RL/AH 14176 7 October 2014

# DA14/0935 - RESUBMISSION OF PLANS JORDAN SPRINGS VILLAGE 5 SUBDIVISION

Figure 3 – Revised Development Staging submitted 7/10/14 Source: RPS

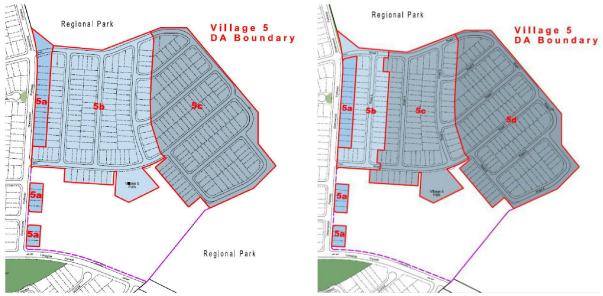
Following a meeting with held between Council and Lend Lease on 11 September 2014 Lend Lease wish to modify the plans to create five (5) substages, being Stages 5A – 5E, with Stage 5E allocated as residue lots for future integrated housing allotments, shown in **Figure 3**.

The revised subdivision arrangement will enable Lend Lease to undertake an integrated development model in four allotments (Proposed Lots 5247-5250) fronting the future East Lake in Village 5 (Proposed Lot 5246). These lots will be developed as integrated sites as part of a separate future DA(s).

As seen in the above images, the lot layout remains the same as the detail lodged on 29/07/2014 and revised plans submitted 21/8/14, with only the staging being altered, and the lots around the lake becoming residue lots. The following appendices to the submitted SEE have been revised to reflect these changes:
